#### RE: Lot 37 Block 8, Volcano Cliffs, Unit 22, SAD 228 6431 Picardia Rd. NW **Grading and Drainage Plan** Engineers Stamp Date 9/19/19 (D10D003E37)

Based upon the information provided in your submittal received 9/20/19, this plan is approved for Grading Permit.

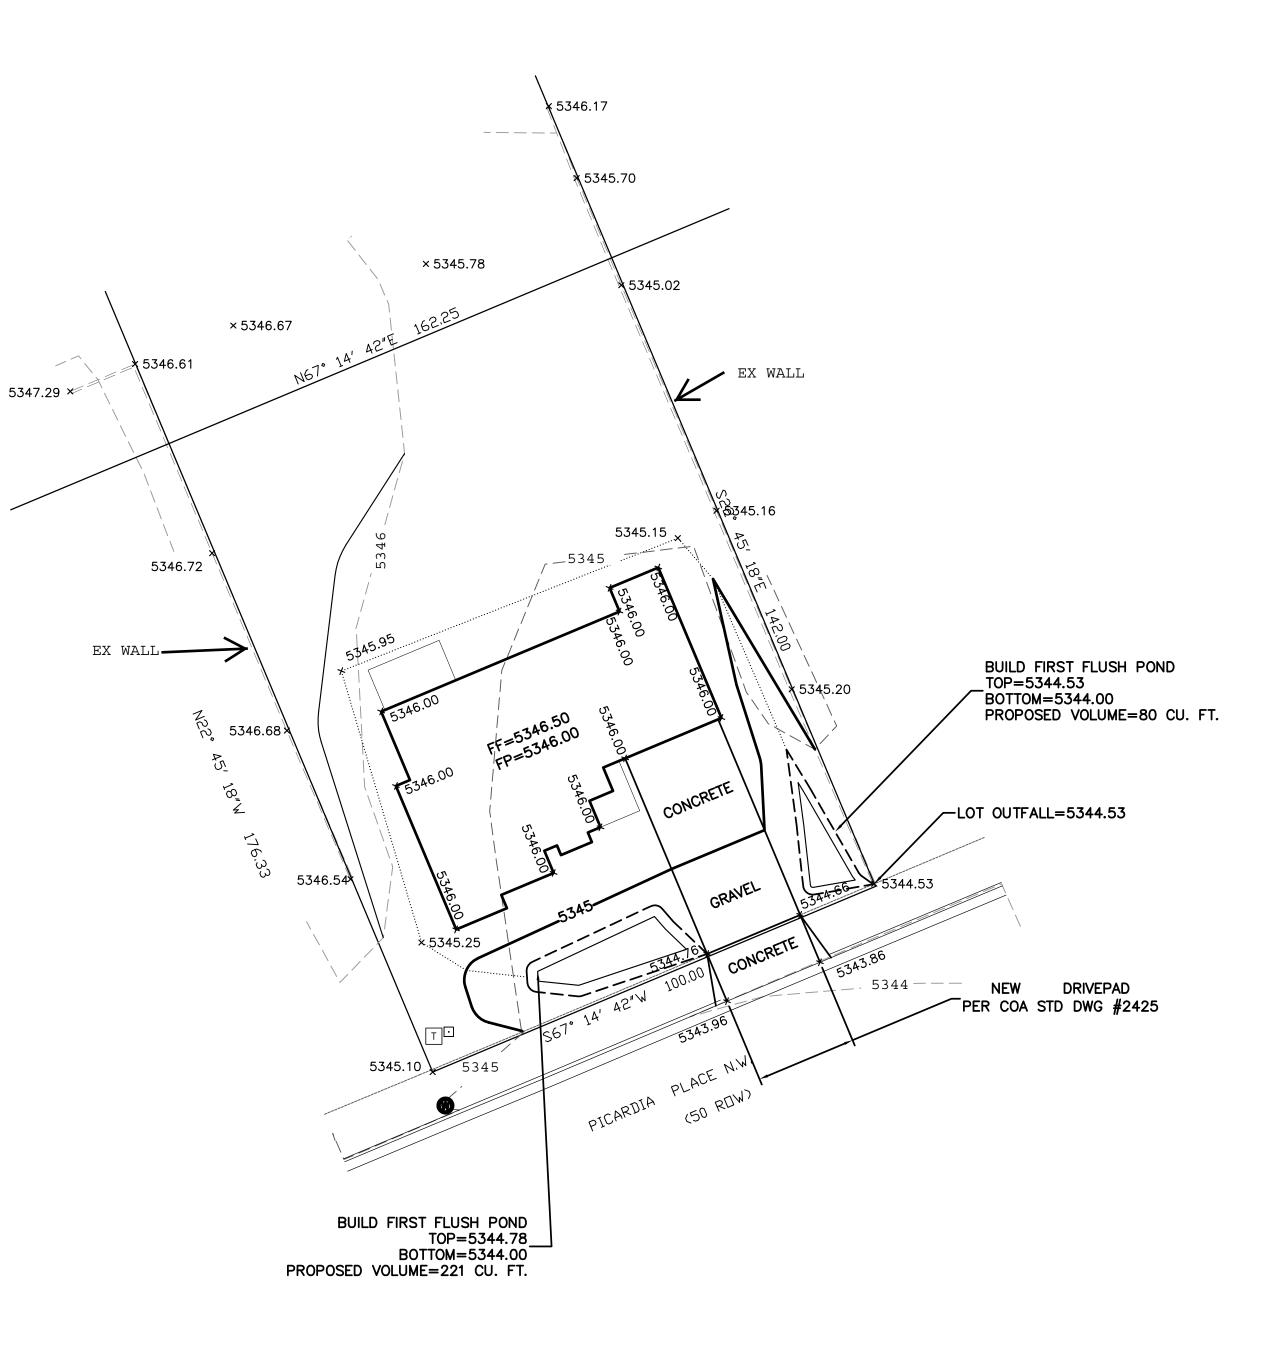
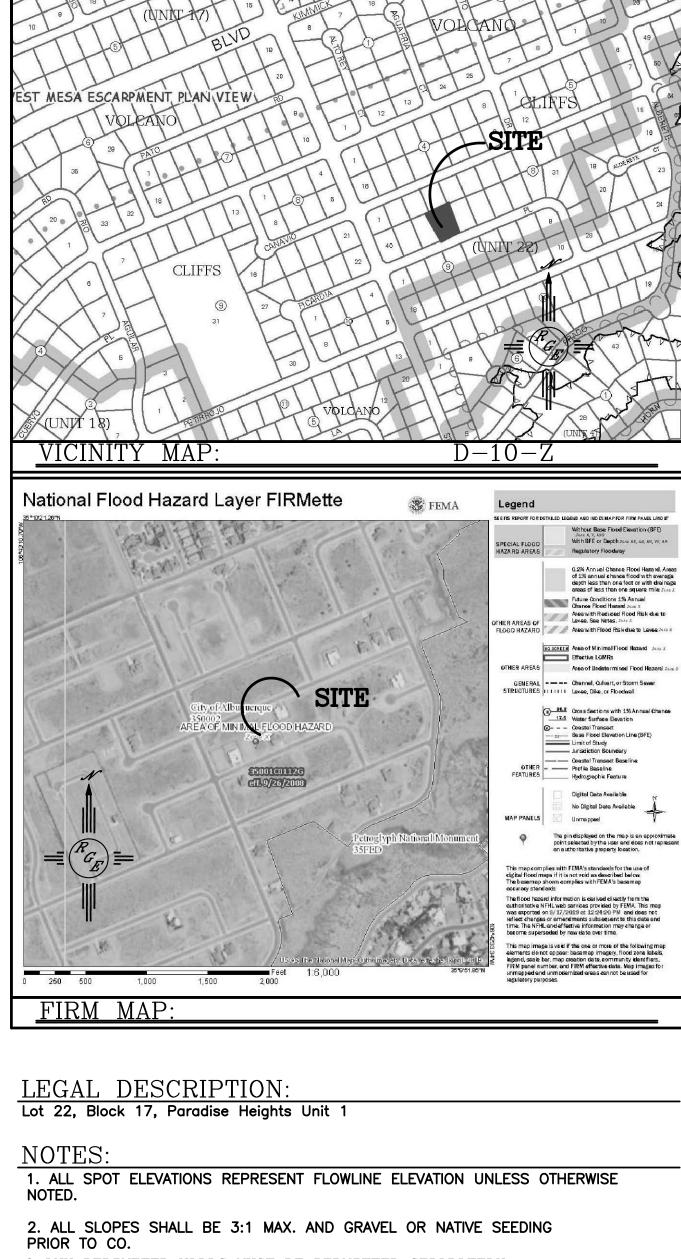
Prior to Building permit approval a Pad Certification will be required, provided by PO Box 1293 the Engineer or a registered Land Surveyor.

Reiterate to the Owner/Contractor that a separate permit for a garden/retaining wall must be Albuquerque obtained with the approved G&D plan and Pad Certification. Also, if a swimming pool is to be placed the grading and drainage plan will change and will need to be resubmitted.

Prior to Certificate of Occupancy release, Engineer Certification per the DPM NM 87103 checklist is required.
